ATTACHMENT 9.7

AREA WALK-BY CHECKLIST

IP3

Status: Y N U Area Walk-By Checklist (AWC) AWC-010Location: Bldg. IS Floor El. 15'-0" Room, Area¹ _____SWEL Components: SWEL1-030, 031**Instructions for Completing Checklist**

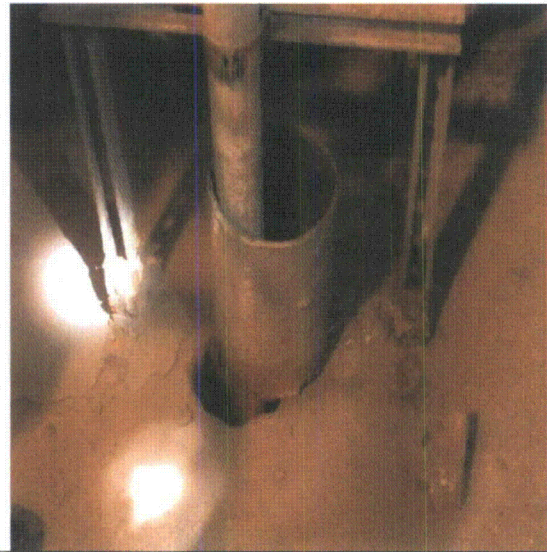
Panel (PID 08219) adjacent to the door: Unistrut legs corroded and broken at the base (see attach photos). The toe plate at the floor penetration between the Unistrut legs is loose and is not protecting the opening (see attach photo).

Note: Corroded and broken Unistrut near door.

Note: Corroded and broken Unistrut near door and a loose pipe protection cover between the Unistrut legs

The above conditions are addressed by CR-IP3-2012-03166.

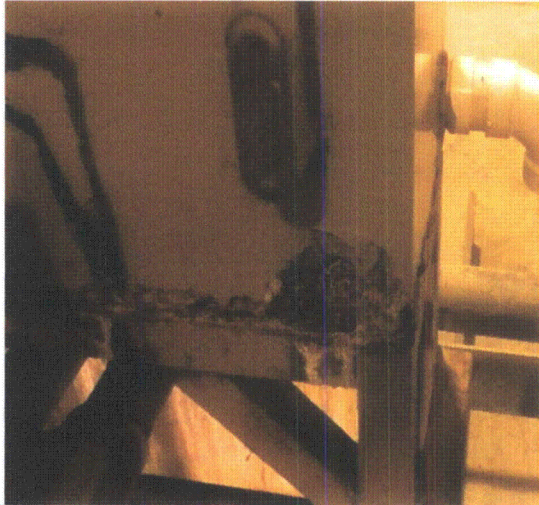
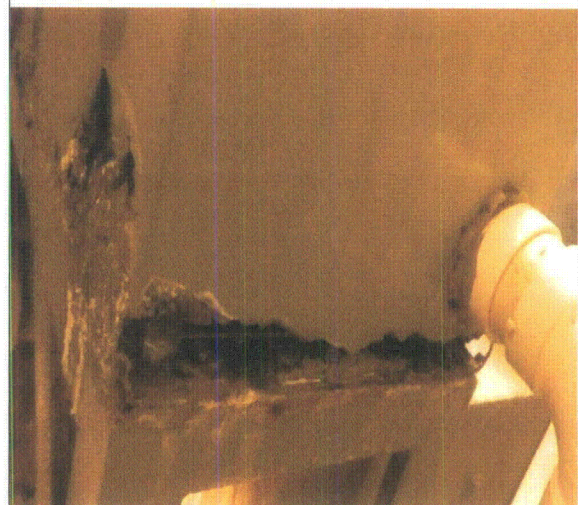
Service Water Pumps Annubars has rotted out at the base. The panel lacks of lateral restraints and is free to displace laterally.

Note: Service Water Pumps Annubars rotted at the base.

Note: Service Water Pumps Annubars rotted at the base.

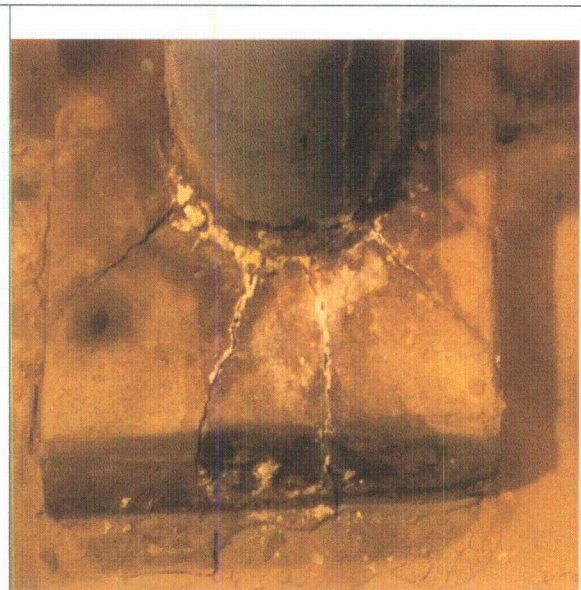
Piping grout penetration protection was found cracked and chipped at various locations allowing water seepage (see photos).

Note: Cracked grout penetration protection

Note: Cracked grout penetration protection

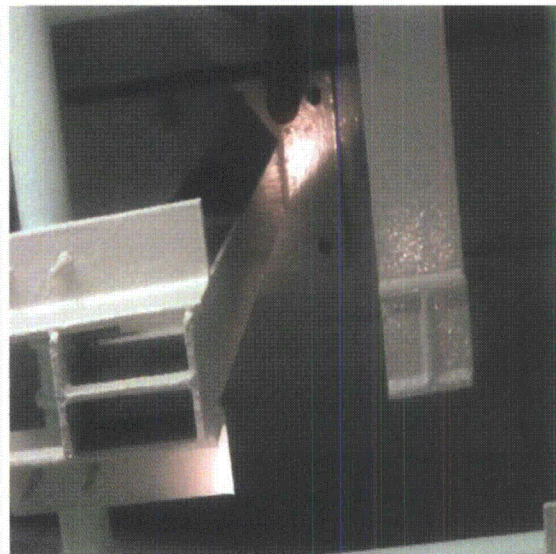
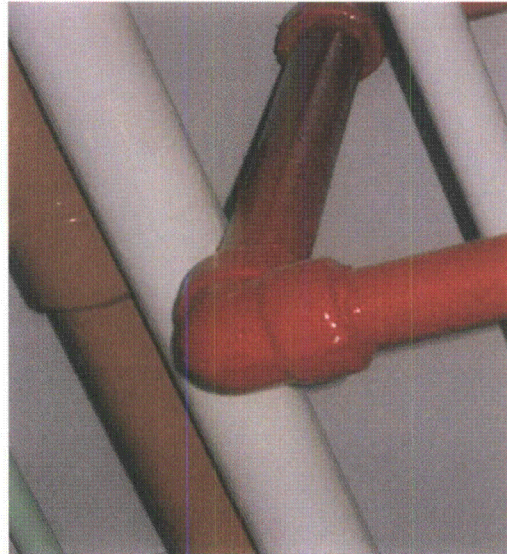
Note: Pipe support with only 4 bolts installed and 2 empty bolt holes.

Note: Fire water line in close proximity to a conduit.

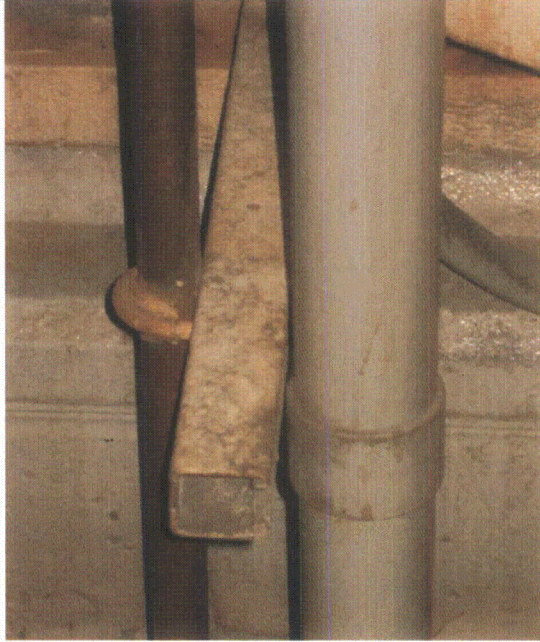
Note: The connection of the conduit riser next to column H8/19.5 is missing the U-bolt attachment to the Unistrut.

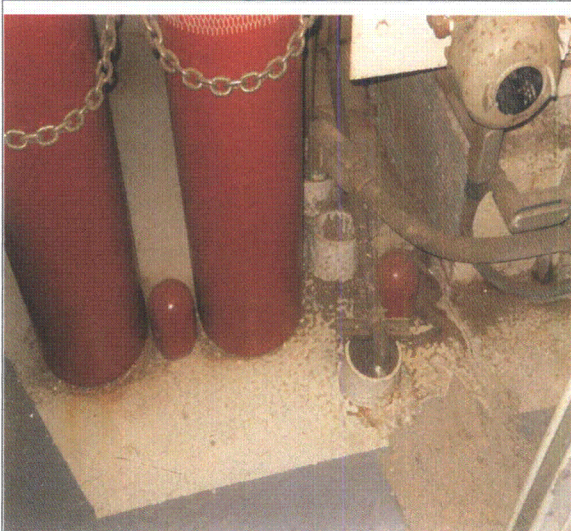
Note: Nitrogen bottles with unsecured caps.

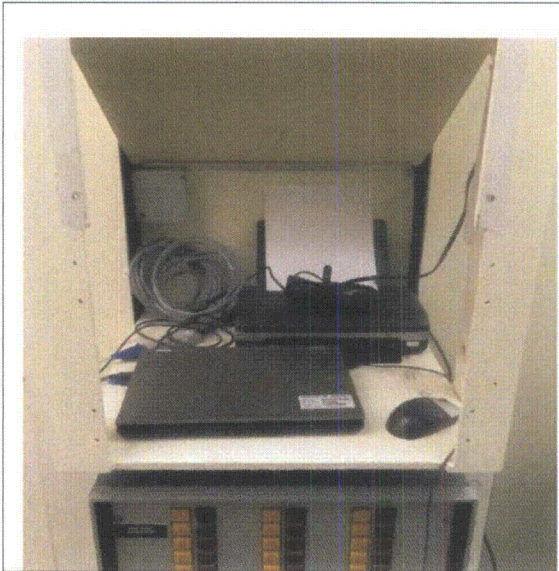
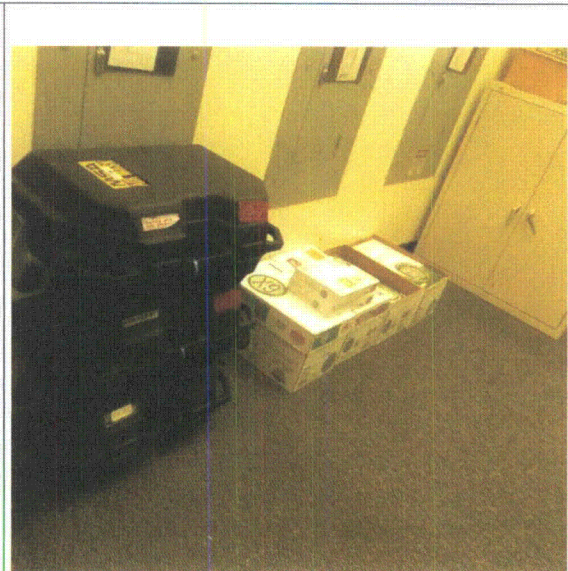
Note: Rack adjacent to Instrument Bus 31 has an unrestrained laptop and printer

Note: Boxes against the west wall on the floor and a box resting on top of a cabinet at the northwest corner of the room

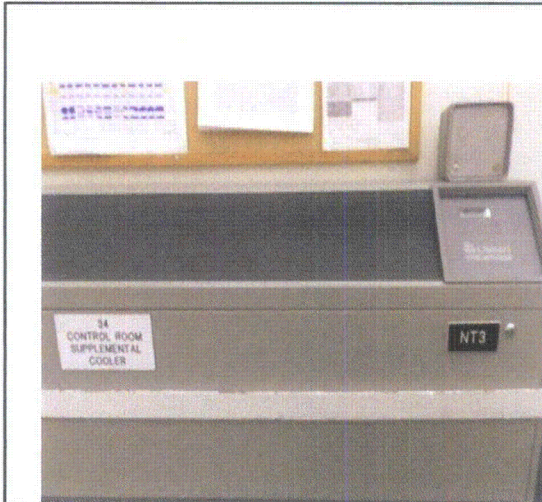
Note: Unrestrained speaker on top of 34 Control Room Supplemental Cooler along the south wall

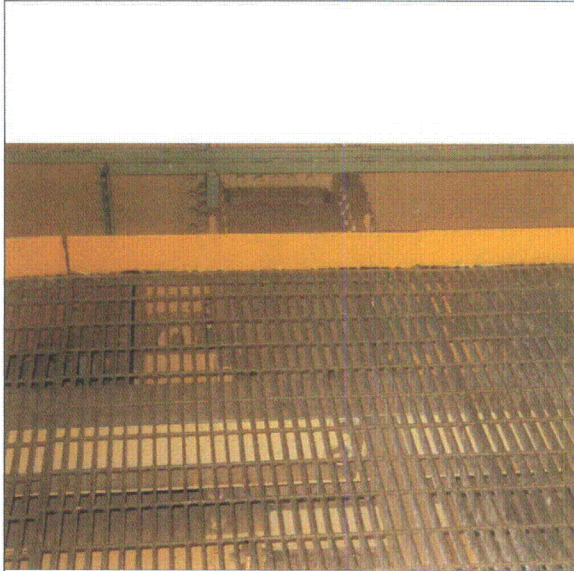
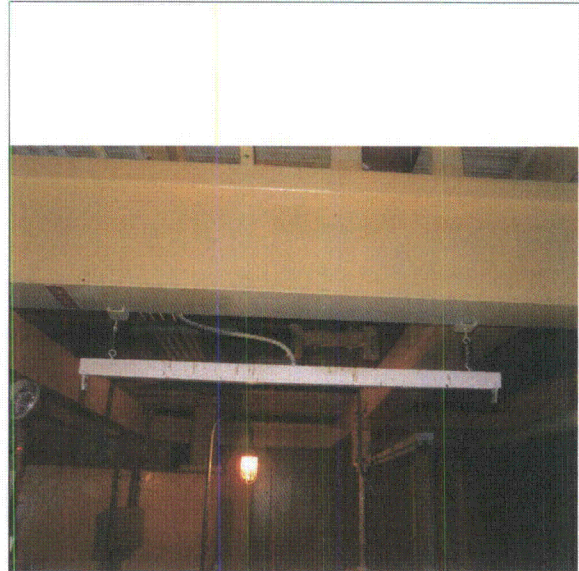
All fluorescent light bulbs in the area need to be secured to the fixture. This is addressed by CR-IP3-2012-03462.

A few fluorescent bulbs near south end of the platform are out and need to be replaced.

Note: Some sections of grating are not attached to the steel beam below.

Note: Some fluorescent bulbs near south end of the platform are out and need to be replaced.

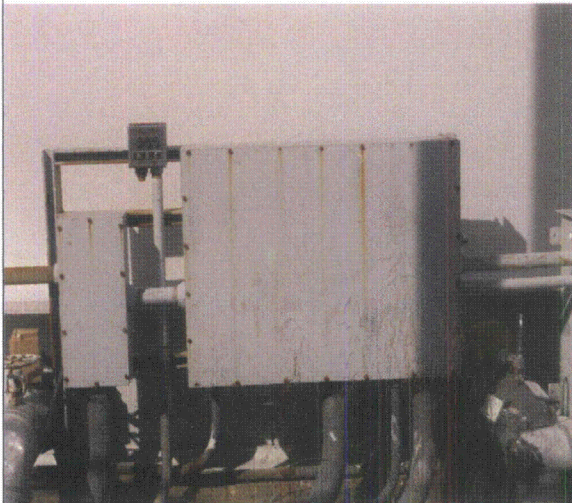
*Several screws are missing from the face closures of the electric panels. See attached photo.
– Since weight of the closure panel is less than 40#, and peak acceleration from ground response spectra is 0.64, 14 out of 22 screws are more than adequate to hold the panel in place.*

Note: Several screws are missing for the electric panels

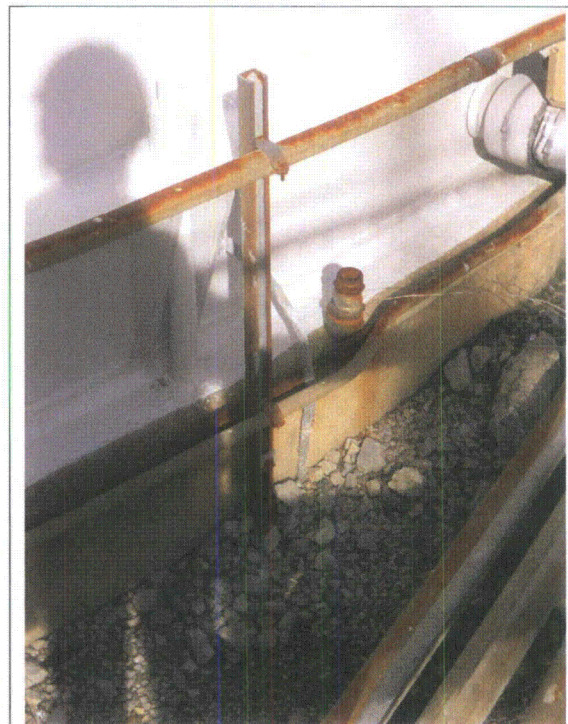
All the conduit and pipes show sign of corrosion.

Note: *All the conduit and pipes show sign of various stages of corrosion.*

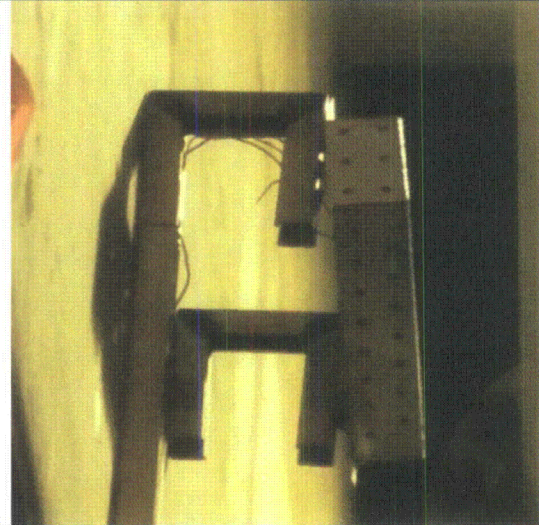
Note: Gap between the base plate and wall.

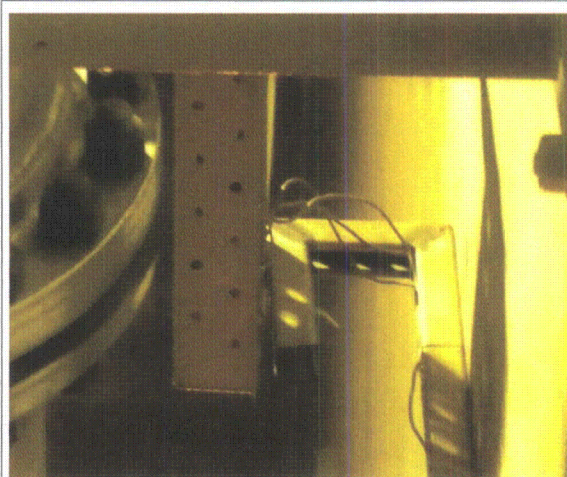
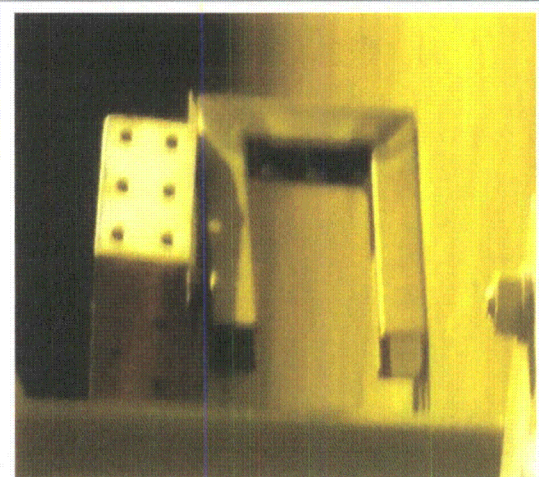
Note: Gaps between wire trough and Unistrut looking south.

Note: Gap between wire trough and Unistrut looking north.

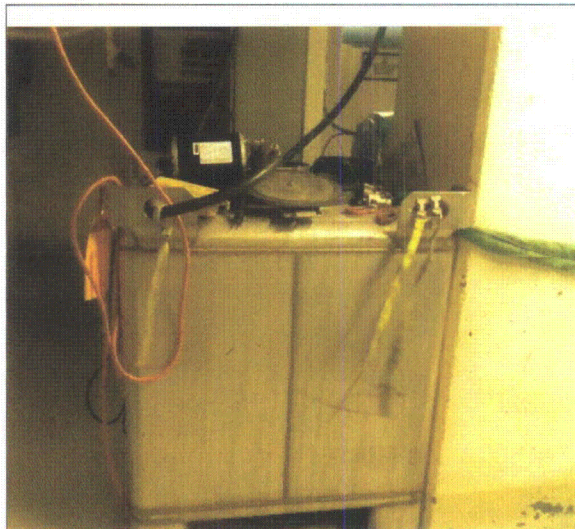
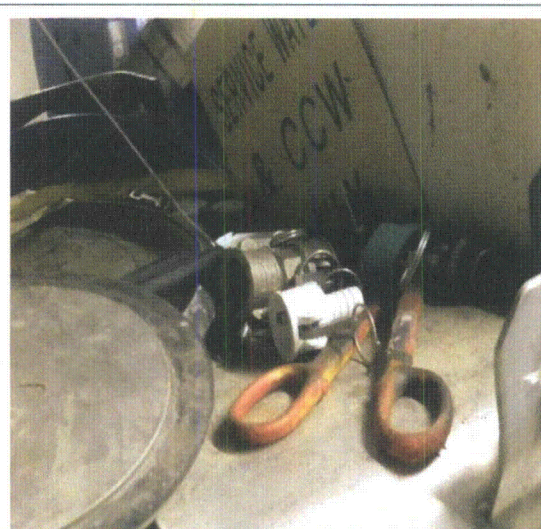
Note: Tools on top of CCW tank

Note: Tools on top of CCW tank

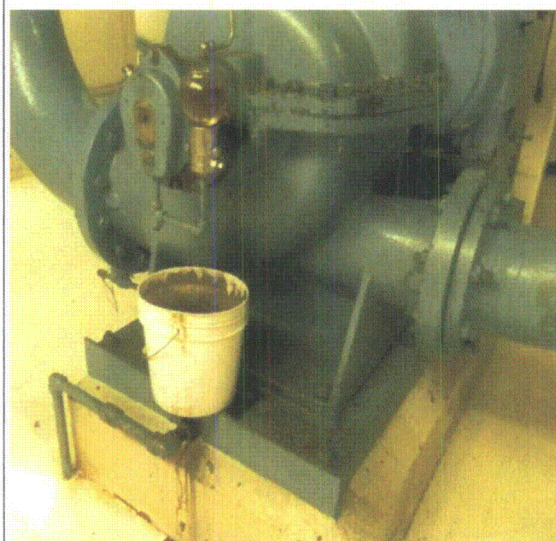
Note: Bucket at 32 CCW pump

Note: Bucket at 32 CCW pump under the oil reservoir

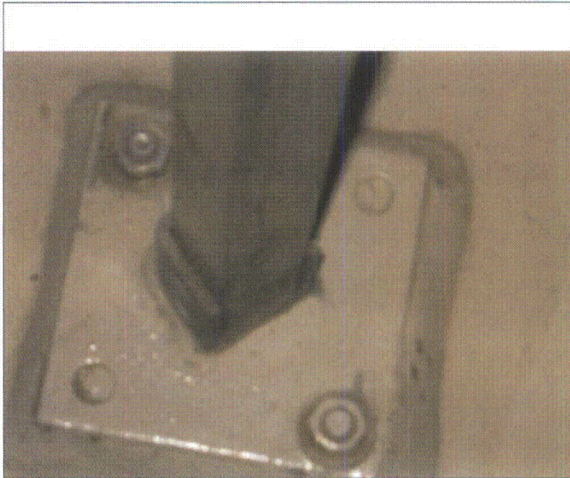
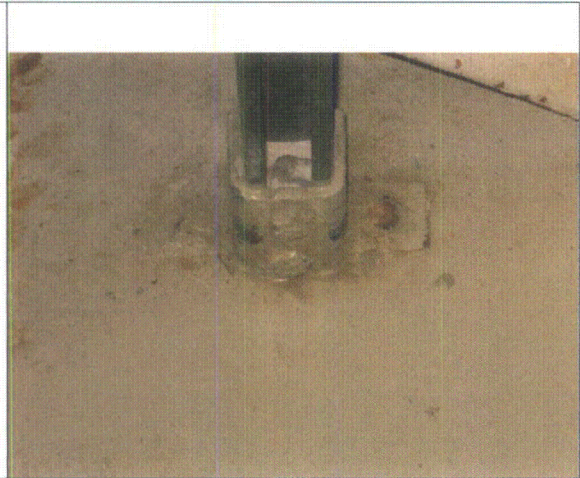
Electric heat tracing cabinet support base plates and anchor bolts are severely corroded. The Unistrut support column has been welded to the stair stringer to provide additional support. CR-IP3-2012-03595 documents this condition. LB-19 has evaluated this condition.

Note: Base plate with two out of four anchor bolts in place.

Note: Electric heat tracing cabinet base plate

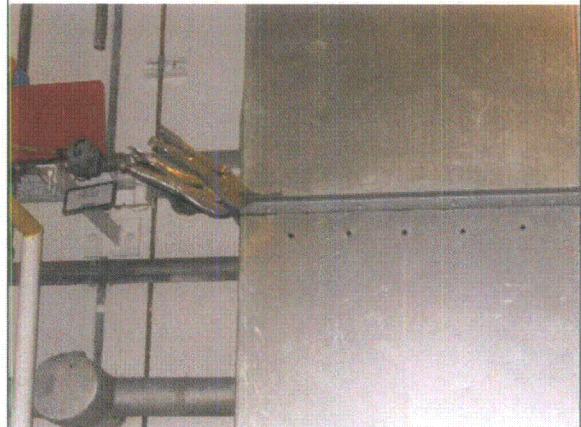
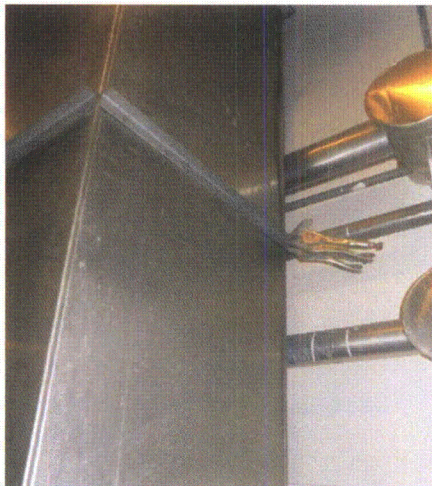
The wall of the duct is light in weight and will not damage the nearby boric acid tank. In addition, total separation from the duct is unlikely; therefore, this is judged to have no adverse seismic condition. CR-IP3-2012-03595 has been written to correct these conditions.

Note: Hot water heater with no apparent restraint

Note: Duct work held together with vise grips

Note: Ductwork with side not connected at corner seam.

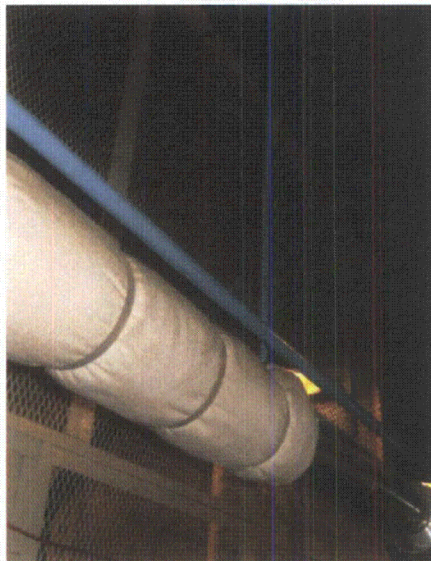
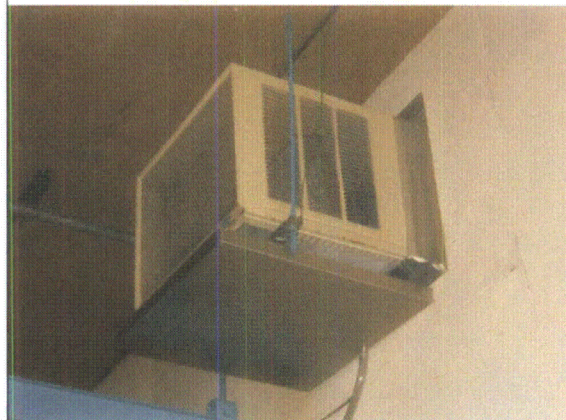
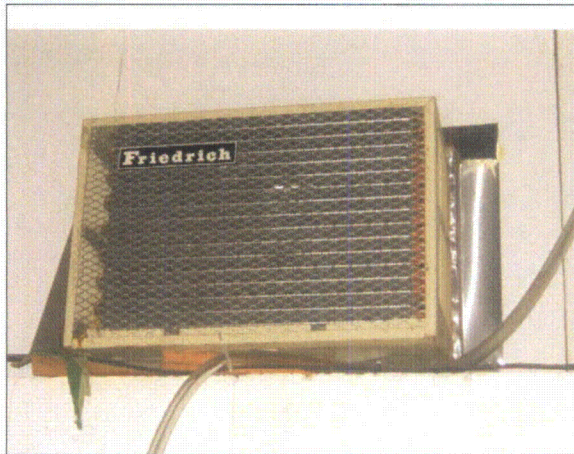
Note: Pipe hanger in close contact with horizontal pipe.

Note: Air conditioner with no apparent horizontal support.

Note: Air conditioner with no apparent lateral support

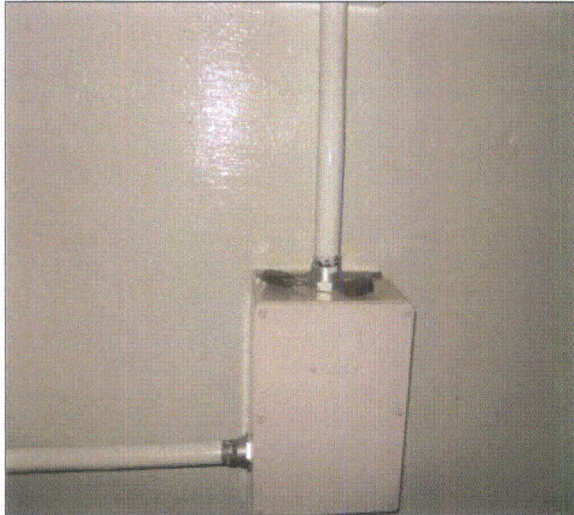
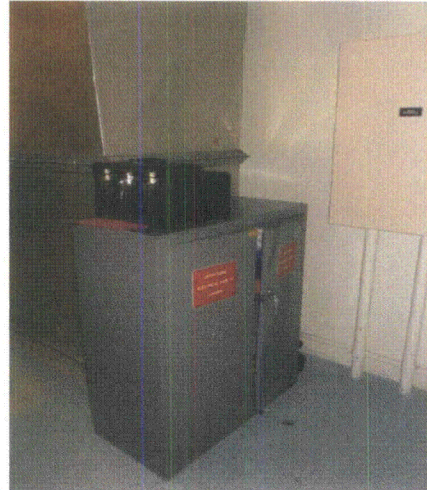
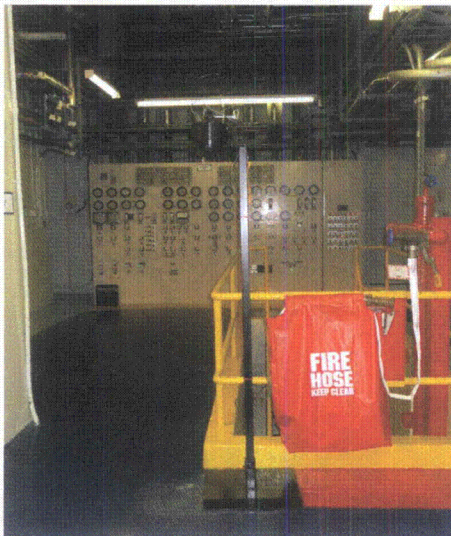
Camera mounted on post with base plate which has no anchor bolts and stands adjacent to the stairway. CR-IP3-2012-03565 has been written to correct this condition.

Note: Loose padlocks on top of cabinet

Note: Unsecured tool box on top of cabinet and cabinet door not closed.

Note: Camera on post with unsecured base plate
